UNITED STATES PATENT AND TRADEMARK OFFICE

APPLICATION NO.	FILING DATE	FIRST NAMED INVENTOR	ATTORNEY DOCKET NO.	CONFIRMATION NO.
10/749,204	12/30/2003	Dae-Hun Cho	11038-170-999	1851
24341	7590	12/21/2005		
MORGAN, LEWIS & BOCKIUS, LLP. 2 PALO ALTO SQUARE 3000 EL CAMINO REAL PALO ALTO, CA 94306			EXAMINER PRICE, CRAIG JAMES	
			ART UNIT	PAPER NUMBER
			3753	
DATE MAILED: 12/21/2005

Office Action Summary	Application No.		Applicant(s)	
	10/749,204		CHO, DAE-HUN	
	Examiner		Art Unit	
	Craig Price		3753

DETAILED ACTION

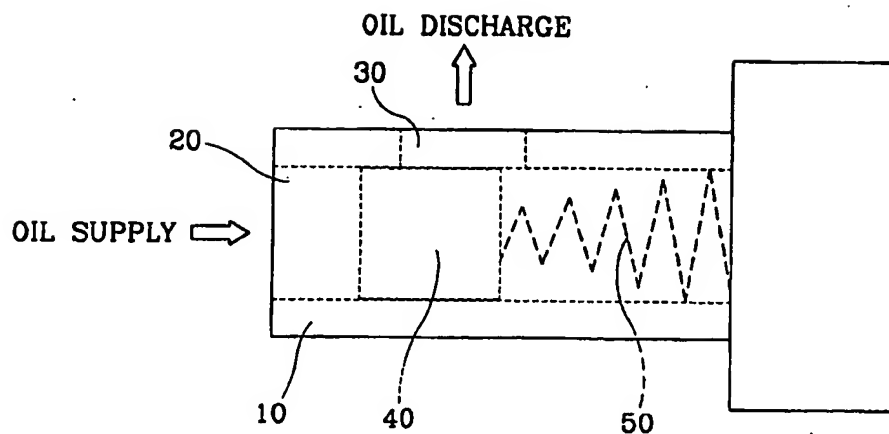
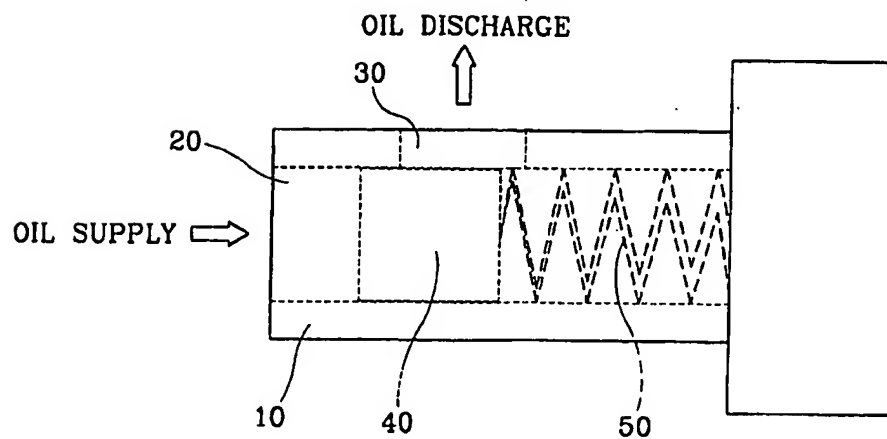
1. The change to the drawing is accepted and the objection is removed.
